[Docket No. 2001-SW-67-AD; Amendment 39-12710; AD 2002-08-03]

Airworthiness Directives; Enstrom Helicopter Corporation Model F-28, F-28A, F-28C, F-28F, 280, 280C, 280F, and 280FX Helicopters

ACTION: Final rule; request for comments.

Figure 1. Main Rotor Shaft Inspection

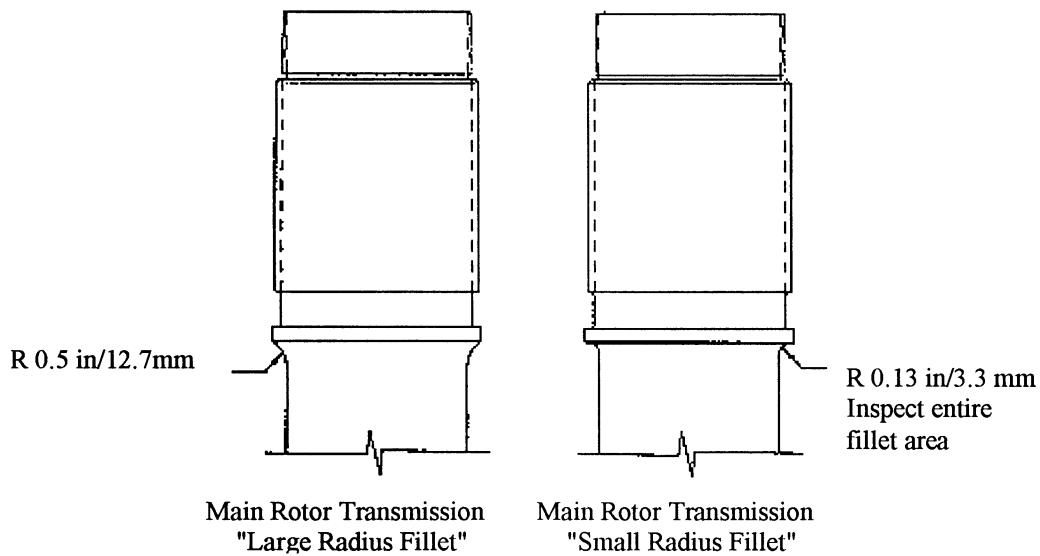
Since the issuance of AD 2001-22-01, Amendment 39-12479, the FAA received a comment that the AD should have cited additional part numbers (part number (P/N) 28-13101-3 and P/N 28-13101-3-R) in Table 1 of the AD. Further, Figure 1 of AD 2001-22-01 contained an error—"2.7mm" is now corrected to state "12.7mm". This AD also corrects another part number and other minor typographical errors. Also, since the issuance of the previous AD, the manufacturer has revised its service information and issued Enstrom Helicopter Corporation Service Directive Bulletin No. 0094, Revision 2, dated February 15, 2002.

(a) Before further flight, determine the part number (P/N) of the main rotor transmission (transmission) and the radius of the upper fillet of the shaft (as shown in the following Figure 1):
